Access Compliance Report

Public Rights-of-Way

Intersection ID: 14999	Main Street: ALCOTT_ST	Cross Street: MONROE_RD	Location: SW
ADA ID: B148F9156A1F	Ramp Type: Perp	Initial Pass/Fail: Fail	Overall Compliance: No
			Severity Score: 33.75

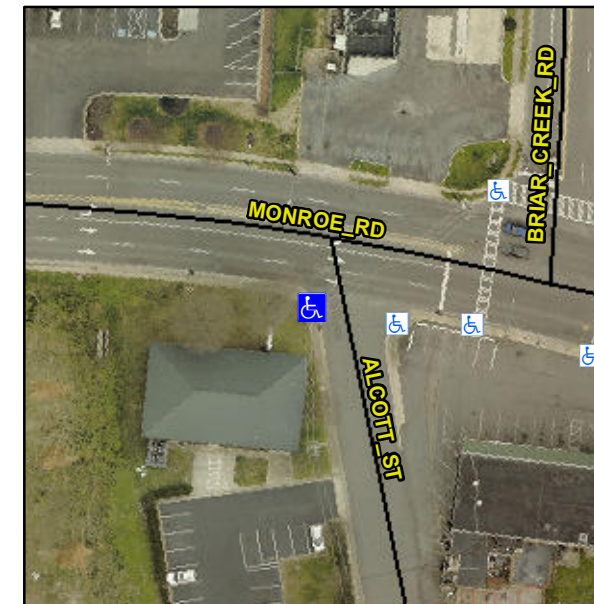
Not Found, R304.5.1, R304.2.2

Compliance	Description	Data	Compliance	Description	Data
N/A	Ramp Length (in)	56.0	No	Ramp Slope (%)	13.6
No	Ramp Width (in)	37.0	Yes	Ramp XSlope (%)	1.2
N/A	Flare Type LT	N/A	N/A	Flare Type RT	N/A
N/A	Flare Slope LT (%)	N/A	N/A	Flare Slope RT (%)	N/A
N/A	Flare Traversable LT?	N/A	N/A	Flare Traversable RT?	N/A
N/A	Landing Length (in)	N/A	N/A	DWS Provided?	N/A
N/A	Landing Width (in)	N/A	N/A	DWS Contrast?	N/A
N/A	Landing Slope (%)	N/A	N/A	DWS Length (in)	N/A
N/A	Landing X Slope (%)	N/A	N/A	DWS Full Width?	N/A
N/A	Landing Curb? (Y/N)	N/A	N/A	DWS Offset (in)	N/A
N/A	Shared Landing?	N/A			
N/A	Gutter Ponding?	N/A	N/A	Gutter Slope (%)	N/A
N/A	Gutter Lip Ht (in)	N/A	N/A	Gutter X Slope (%)	N/A
N/A	Painted X Walk1?	No	N/A	Painted X Walk2?	N/A
	X Walk 1 Direction	To SE		X Walk 2 Direction	N/A
N/A	X Walk 1 Width (in)	N/A	N/A	X Walk 2 Width (in)	N/A
	X Walk 1 Slope (%)	0.9		X Walk 2 Slope (%)	N/A
	X Walk 1 X Slope (%)	0.2		X Walk 2 X Slope (%)	N/A

Remove & Replace Entire Ramp.
